Legends Resort & Casino

Bid Package 1 – Envelope

Addendum No. 02

Date: July 7, 2023

At the rear of the V-STICK are positioning posts that allow for alignment during installation and also ensure the required space for the flat jumper cables is maintained.

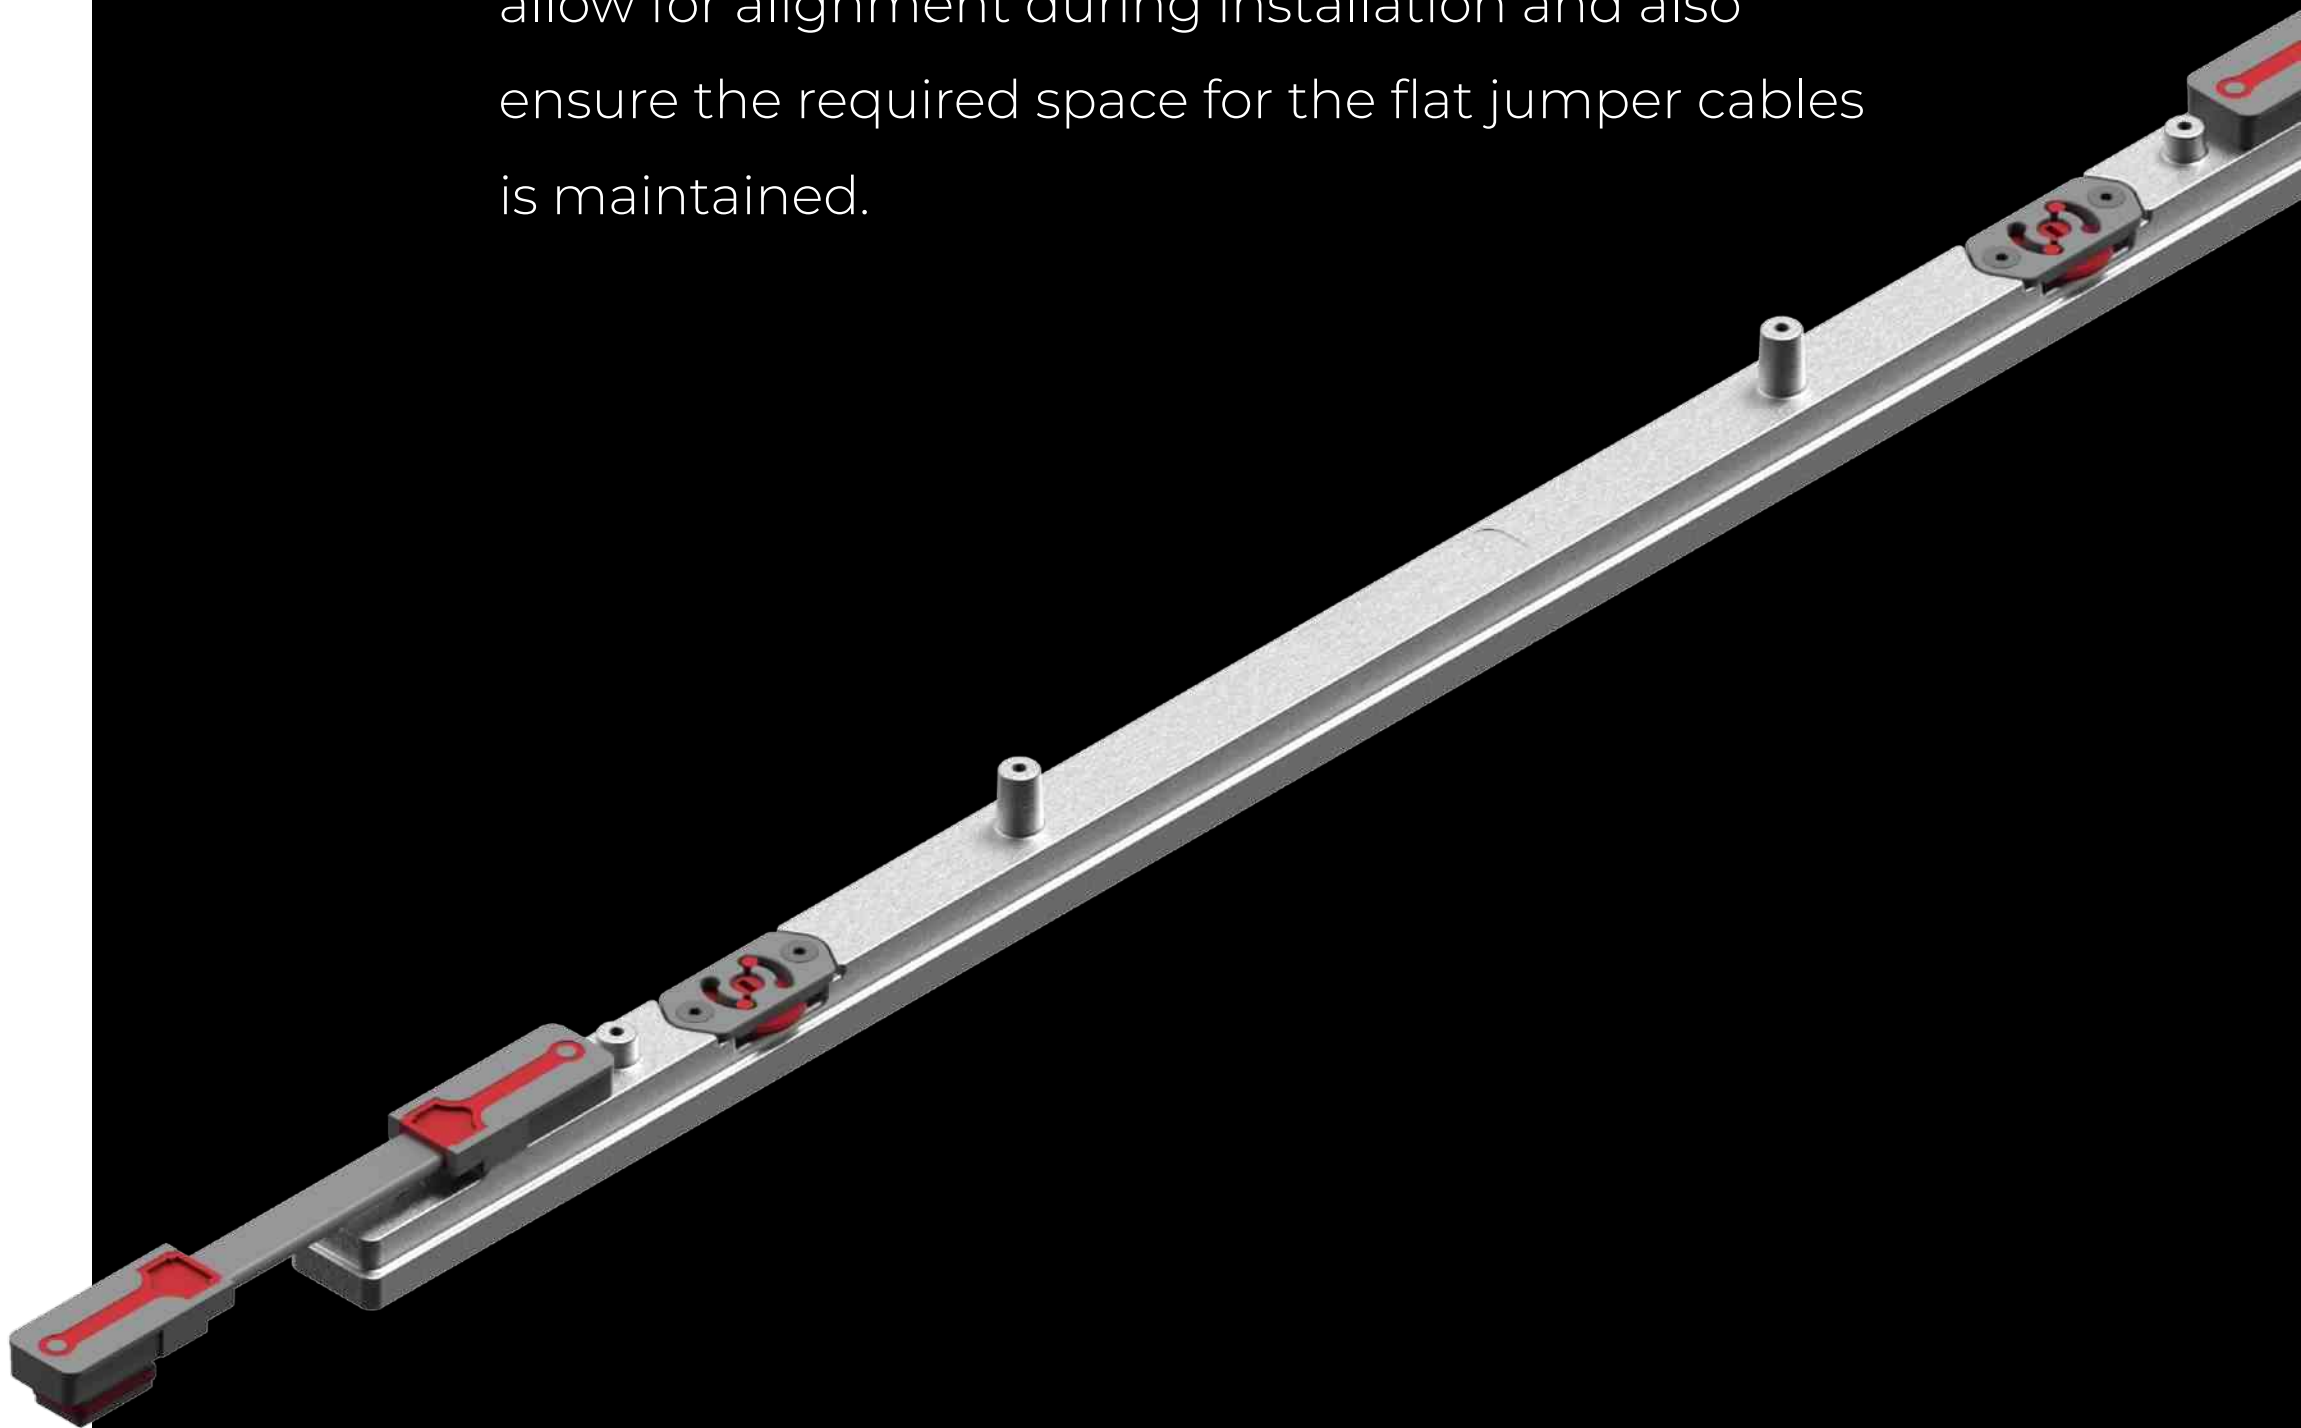
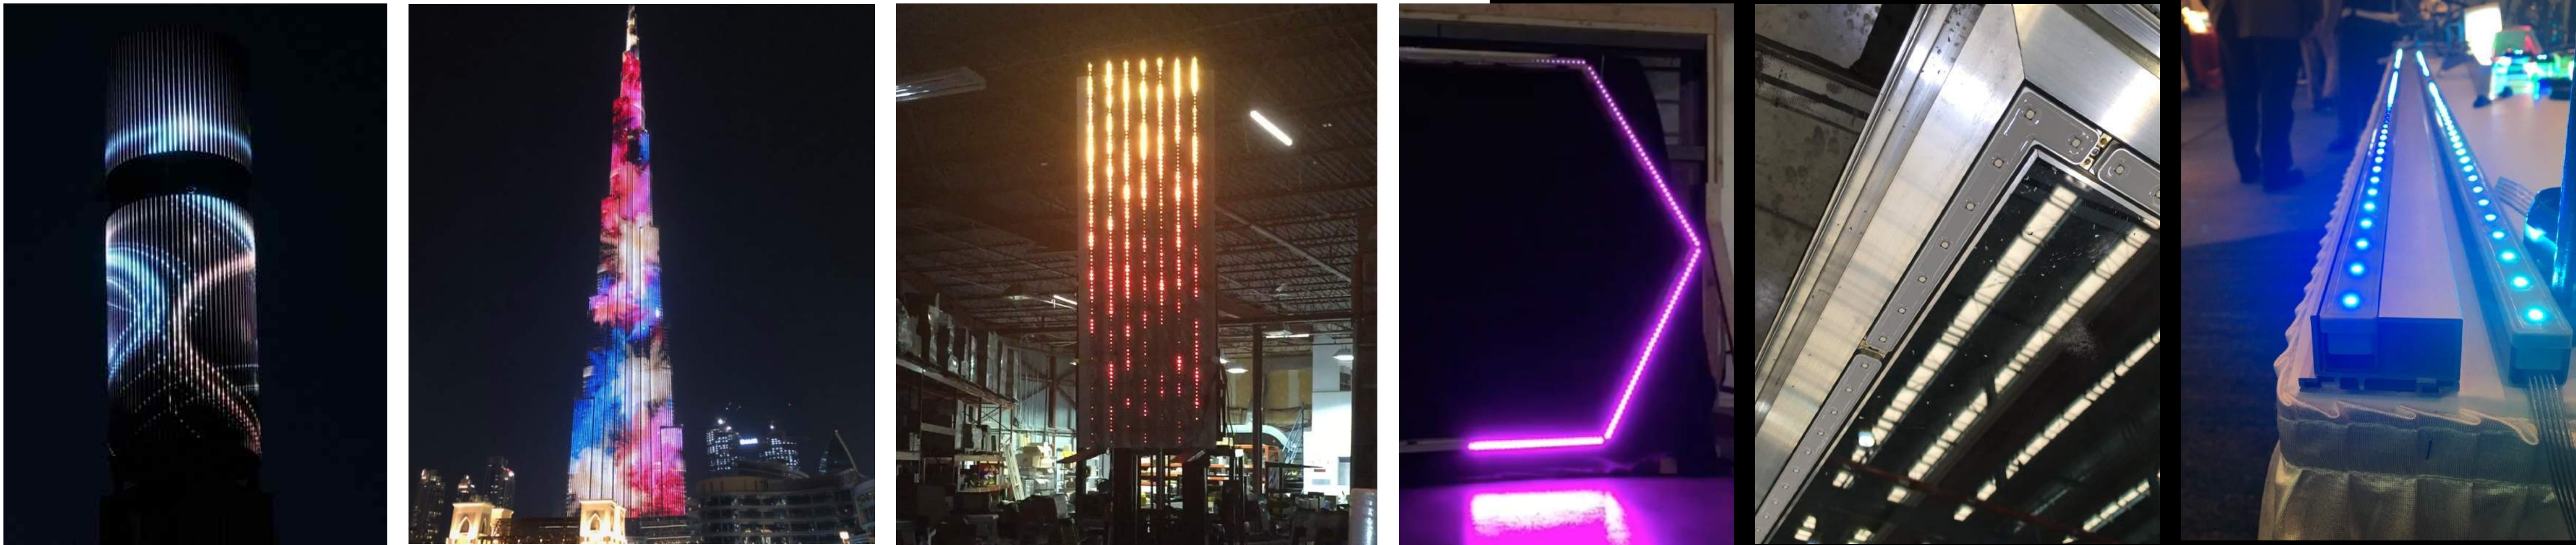
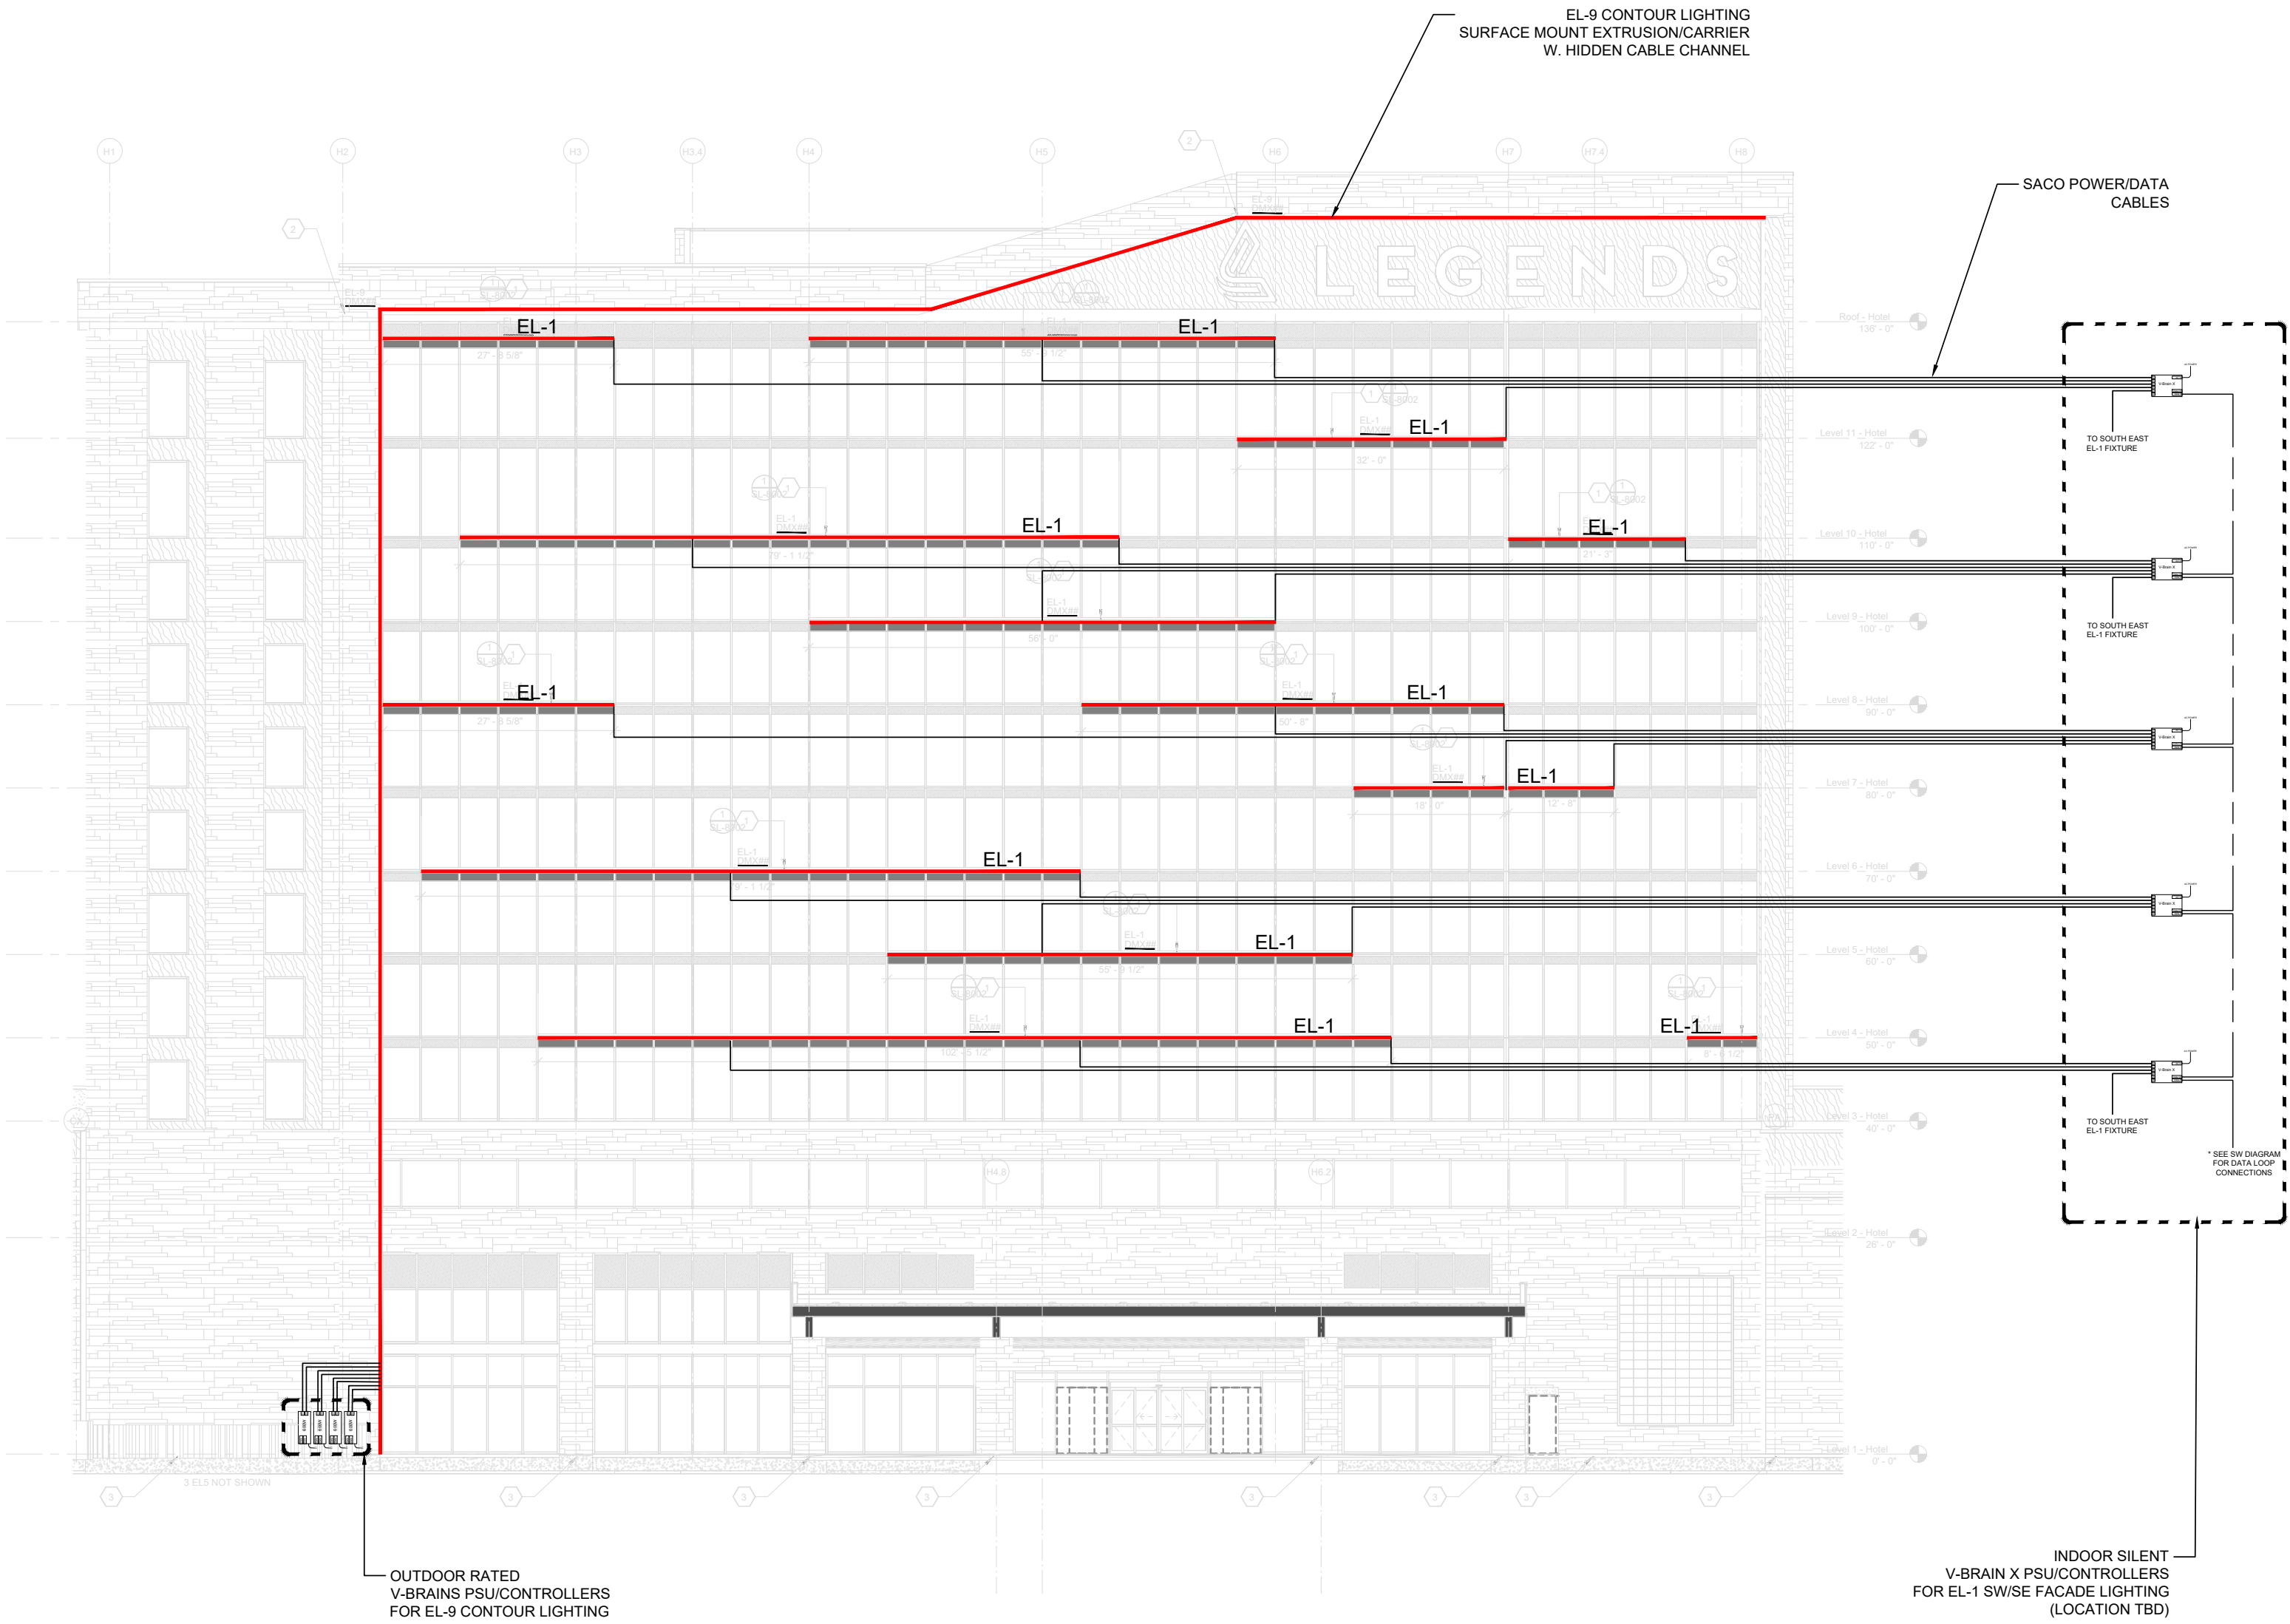
- 04) [Question] Unitized curtain wall system includes mullion mounted exterior strip lighting. Contractor required coordination for this work. We will need additional information regarding the mullion mounted exterior strip lighting so we can confirm attachment to the curtain wall. Also, please confirm that the exterior strip lighting will be by others and that curtain wall contractor will only need to coordinate this work. {This includes all embeds and anchorage.} Please confirm if it's CDI's intent to have the curtain wall contractor supply the embeds for the project.
[Answer] This question is with the design team and response is pending. See the product data attached to this Addendum 02 Q/A narrative sheet labeled as "Appendix A" for the proposed exterior hotel tower strip lighting system for your reference. The proposed manufacturer is SACO's V-Stick lighting system that is to be furnished and installed by the electrical/specialty lighting contractor including mounting accessories to

the curtain wall system. Exterior curtain wall contractor's responsibility is to coordinate with CDI Contractors, the electrical contractor, and the lighting manufacturer prior to final submittal approval and start of curtain wall production. Please assume that the curtain wall contractor will need to include incorporation of a seamless strip lighting design within the curtain wall system.
